## MEMORANDUM

RE: **Site Source Control (SSC) Work Plan Addendum No. 7  
Proposed Termination of the SSC Sampling Program  
GM Powertrain Bedford Facility  
Bedford, Indiana**

figure 2.5

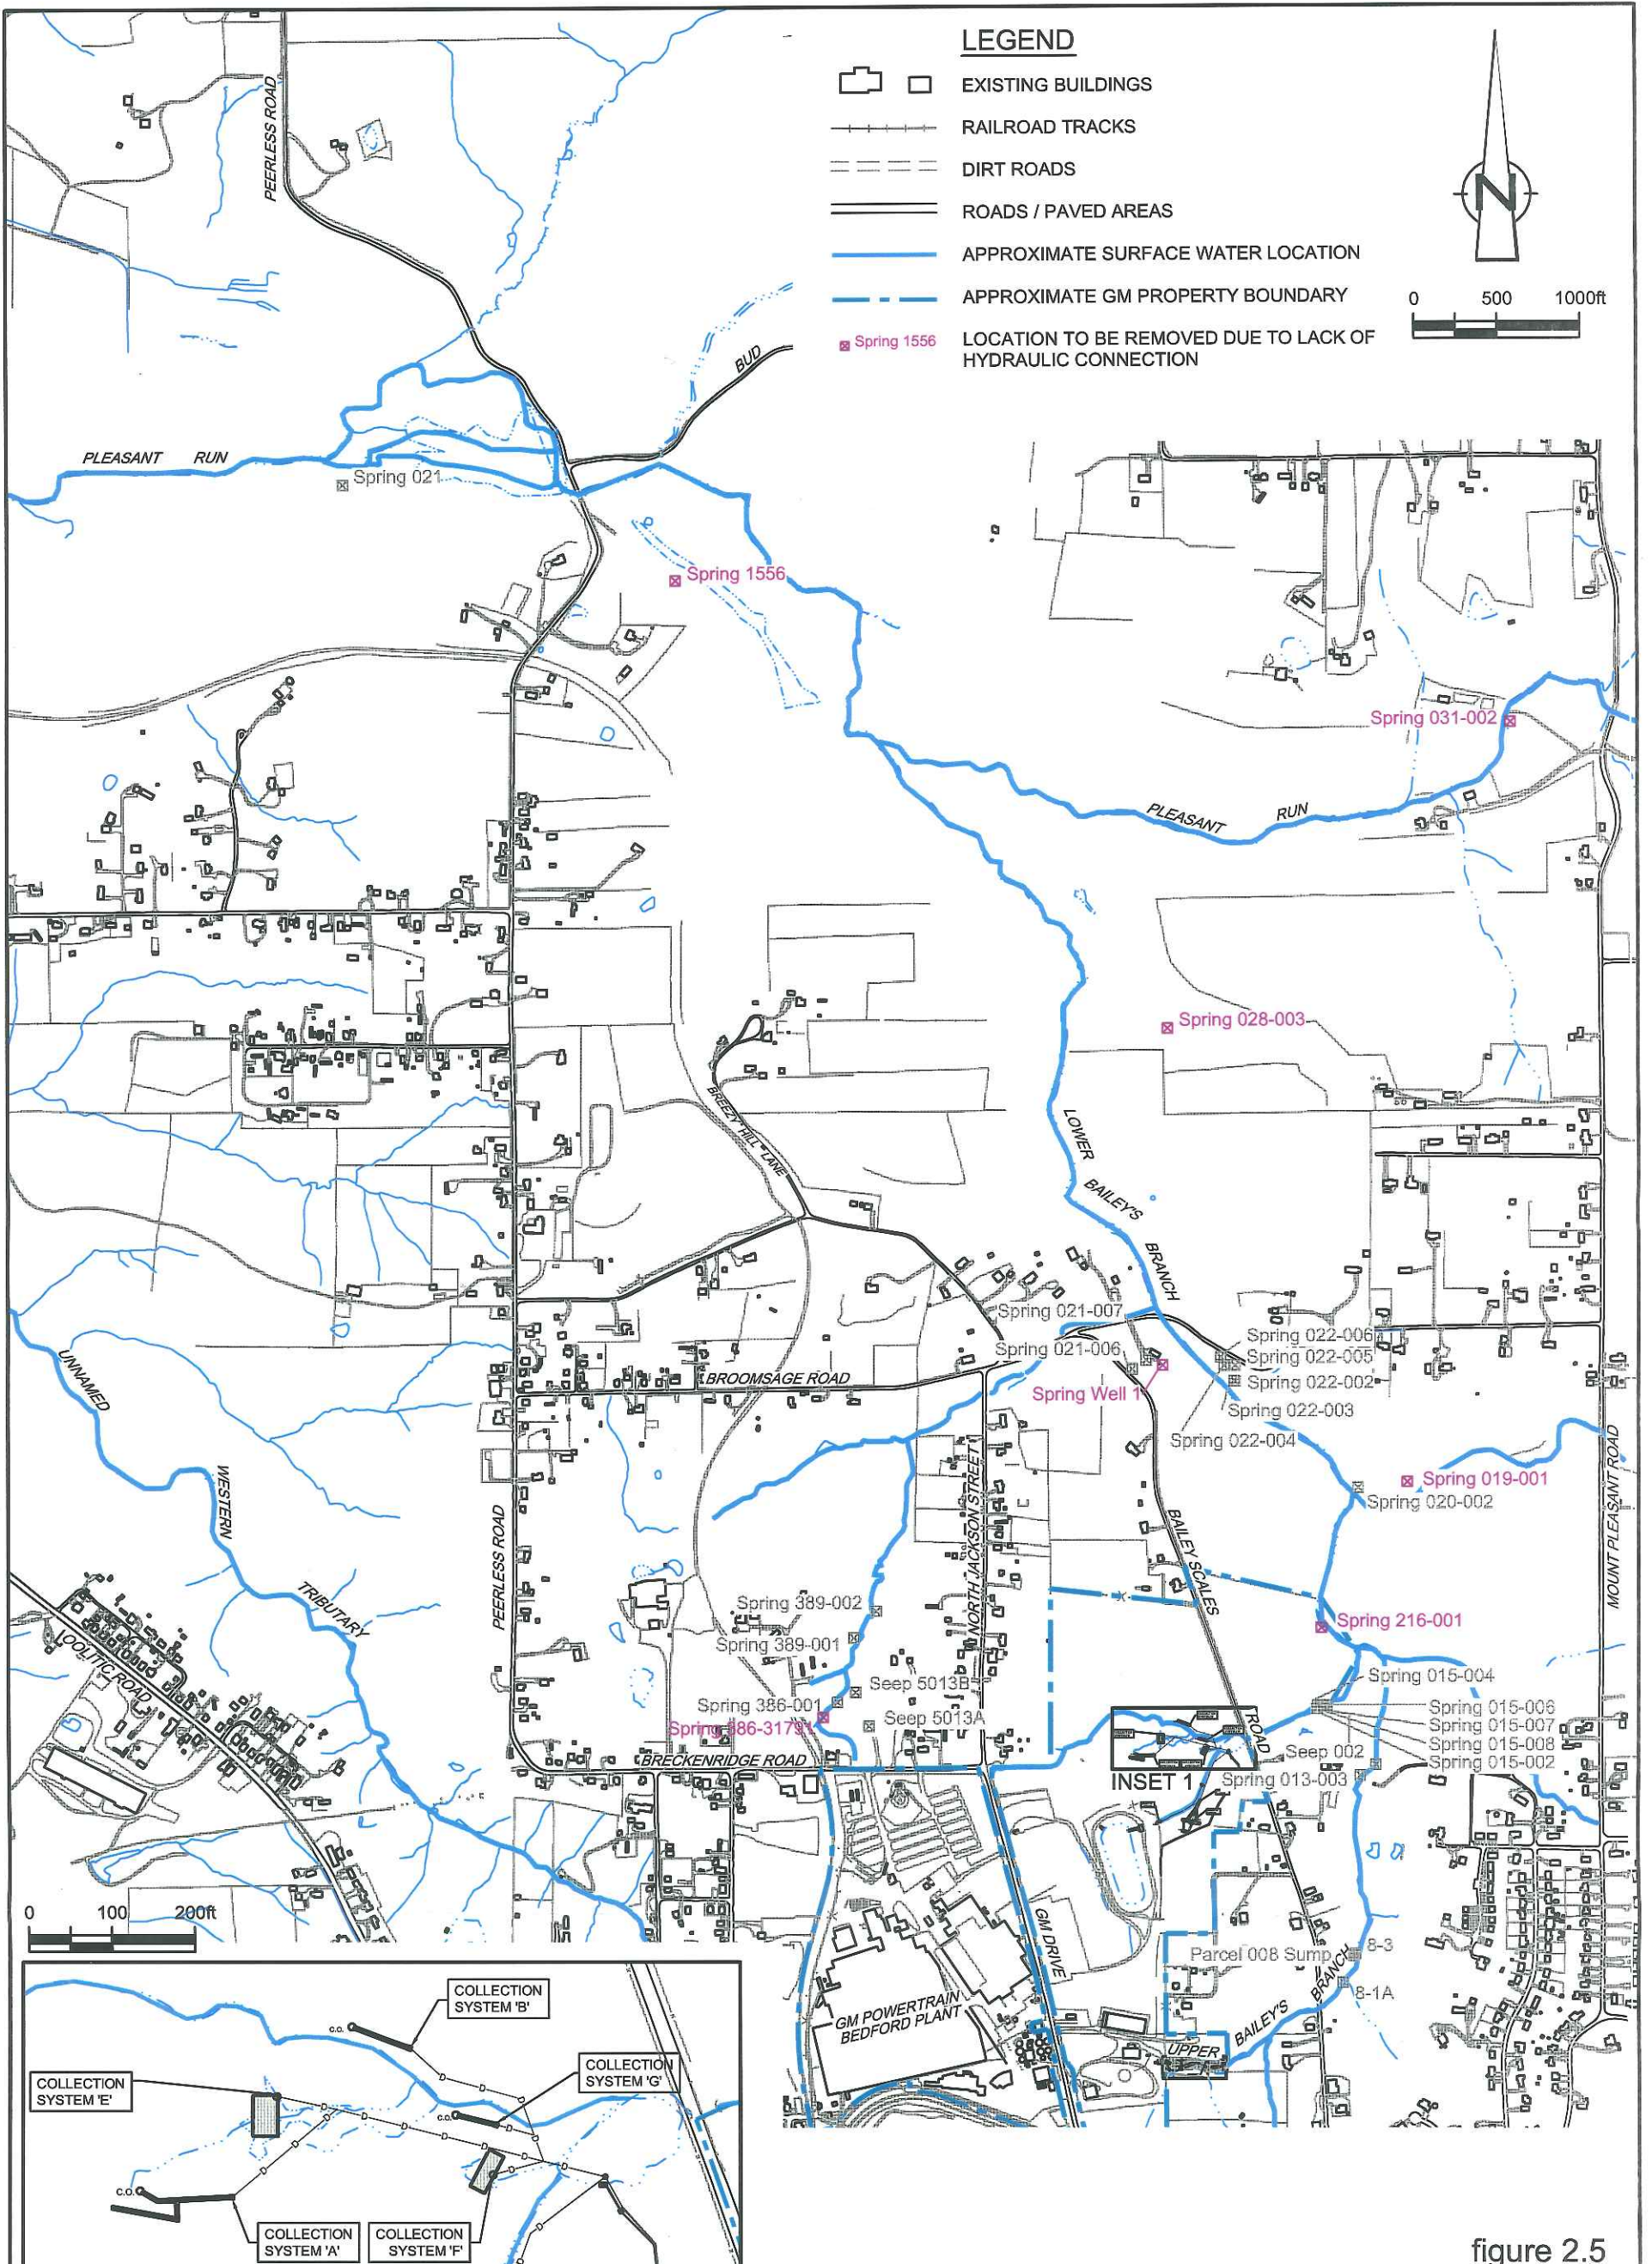
The following seven seep and spring locations are proposed to be removed from the Monitoring Program:

- Spring 019-001: This spring is located on the east side of Bailey's Branch Creek. Based on the groundwater hydraulics and results of the dye testing in this area, this spring is believed to be fed from the east and is not expected to be impacted by the GM Plant, which is located west of the Creek. Flow has not been observed at this location.

- Spring 028-003: This spring is believed to be fed from the uplands to the east and has consistently been shown to not be impacted.
- Spring 031-002: This spring is located well outside of the surface water basin and groundwater basins that have been shown to be impacted from historic releases.

- Spring 216-001: This spring is generally inaccessible and is located along the rock face that was covered with shotcrete; a large deep pool of water is located immediately beneath this location, making it difficult, if not impossible, to access the spring. Two samples have been collected historically from this spring location (did not exist prior to the shotcrete); both were non-detect. The source of groundwater

for this location is the uplands to the west (north of the Plant property) where groundwater contamination has not been found.

- Spring 386-31791: This spring appears to be fed from uplands to the north of the Northern Tributary. The initial detection at this spring is believed to have been the result of entrained soil particulates within the sample that was collected during the time that Interim Measures (soil removal) activities were on-going in the area. Subsequent analyses from this spring have been non-detect for PCBs.

- Spring 1556: This spring is believed to be fed from the uplands to the south and is well beyond any known groundwater contamination. There was one historic estimated concentration reported from this location, however, it is believed that was due to floodplain soil impact (inadvertent introduction of floodplain soil into the sample during collection), rather than the groundwater source. Subsequent testing has been non-detect.

- Spring Well 1: This spring is located within the floodplain and appears to drain the uplands to the west of Parcel 22. There have been historic detections from this location. However, it is believed that all detections are a result of inadvertent introduction of soil particulates during sampling (the area around the spring was below the soil cleanup standard and, therefore, not excavated during cleanup activities at this parcel).
